STAFF REPORT

Case Number: 2022-DV1-057
Address: 4001 North Park Avenue (approximate address)
Location: Washington Township, Council District #7
Zoning: D-5 (TOD)
Petitioner: Brandi Waddy
Request: Variance of development standards of the Consolidated Zoning and Subdivision Ordinance to provide for street access to an existing detached garage (access from an improved alley required) and legally establish the existing 0.60-foot north side setback and 4-foot east rear setback (five-foot side and rear setbacks required).

ADDENDUM FOR FEBRUARY 7, 2023

2022-DV1-057; Proposed Site Plan

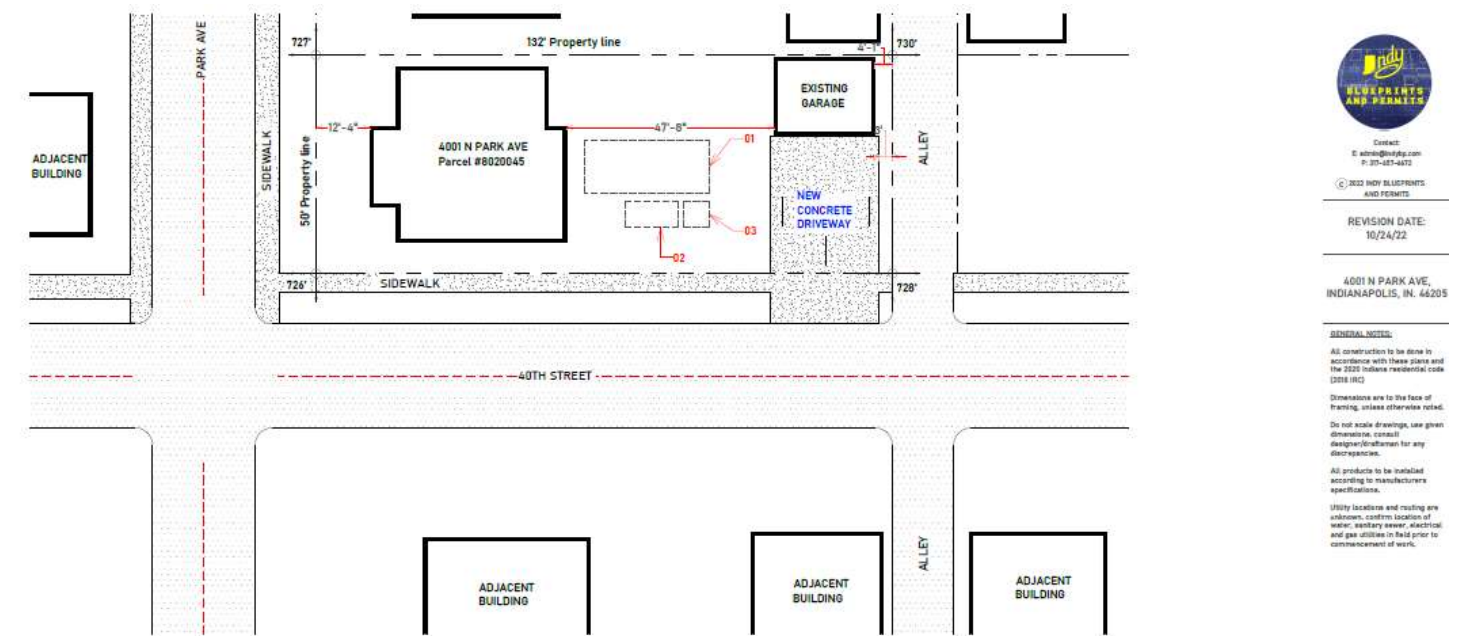
- ◇ The grant of the request would allow for street access from 40th street where it is not permitted. Additionally, it would legally establish the existing setbacks of the detached garage.

- ◇ The grant of the request would be injurious to the safety and general welfare of the community by increasing the number of new curb cuts across sidewalks, which would disrupt the pedestrian experience along the sidewalk and increase the probability of accidents. Instead, the curb and sidewalk could be repaired to meet the right-of-way standards and the driveway could be relocated along the eastern property boundary for alley access.

- ◇ The strict application of the terms of the zoning ordinance would not result in practical difficulties in the use of the property because any existing concrete/cement block wall along the fence or eastern property boundary could be removed and paved to allow for a more accommodating parking area/drive from the alley without the need for a variance.

2022-DV1-057; Staff Exhibit 1- Clear Sight Triangle

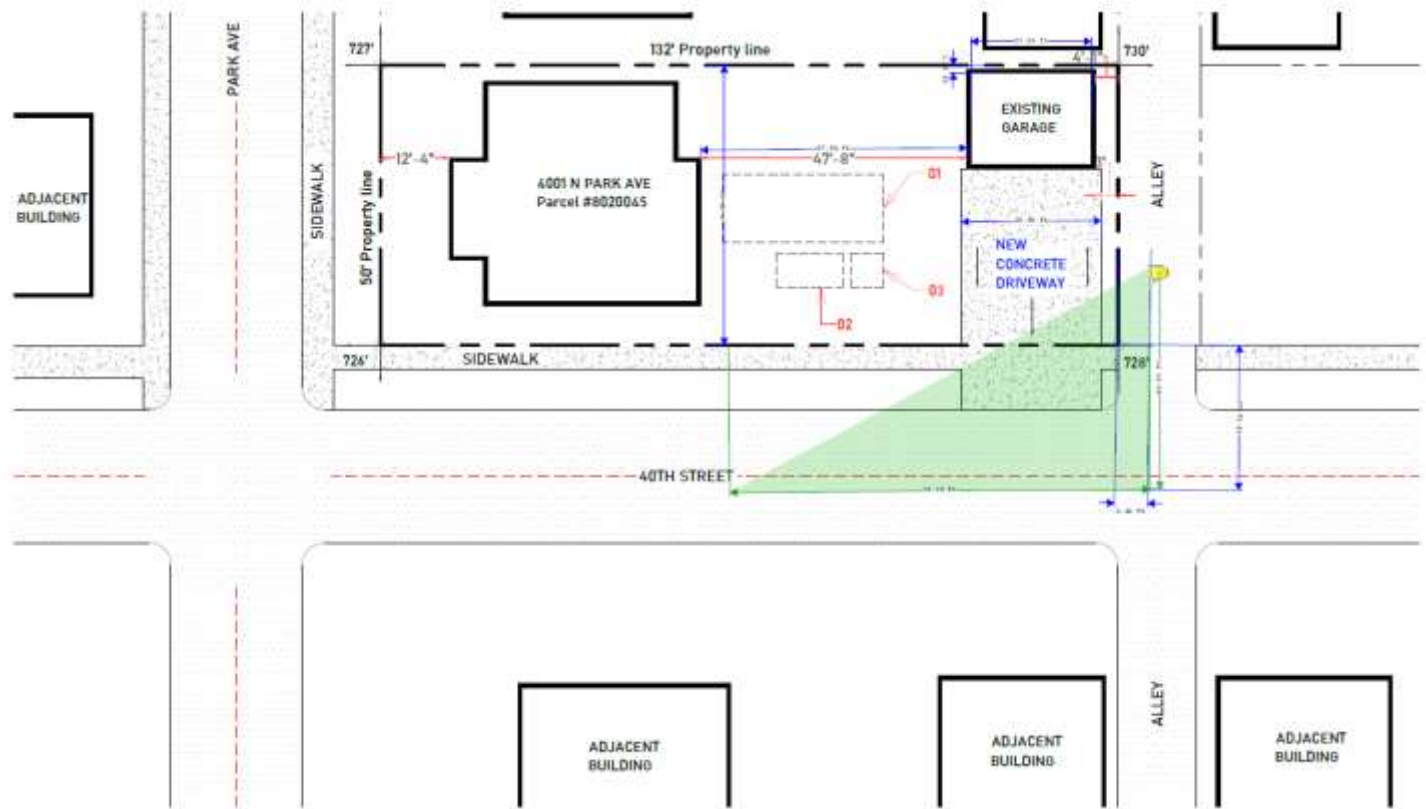
- ◇ The Ordinance, specifically 744-503.H, states “no obstructions shall be erected, placed, planted or allowed to grow in such a manner as to materially impede visibility between the heights of 2.5 feet and 8 feet above grade level of the adjoining right-of-way within a Clear Sight Triangular Area.” The clear sight triangular area is formed by the right-of-way centerline and the centerline of the driveway and the line connecting the two end points. The clear-sight triangle requirement is to provide for sight visibility for motorists at an intersection. Reduction in visibility at intersections would increase the possibility of motorists or pedestrian accidents.

- ◇ Staff’s Exhibit 1 notes the clear sight triangle at the street and alley. The petitioner confirmed that they would ensure that the clear sight triangle would be visible by removing the portion of the fence located in this area. However, a revised site plan has not been provided to confirm that it will be removed.

- ◇ Additionally, there is some discrepancy whether the six-foot fence is within the right-of-way of 40th Street. A revised site plan noting the exact location of the fence was requested, but it has not been provided to staff.

- ◇ Therefore, these items would not be included with this variance unless the petitioner intends to provide an updated site plan and requests to continue this petition for an amendment.
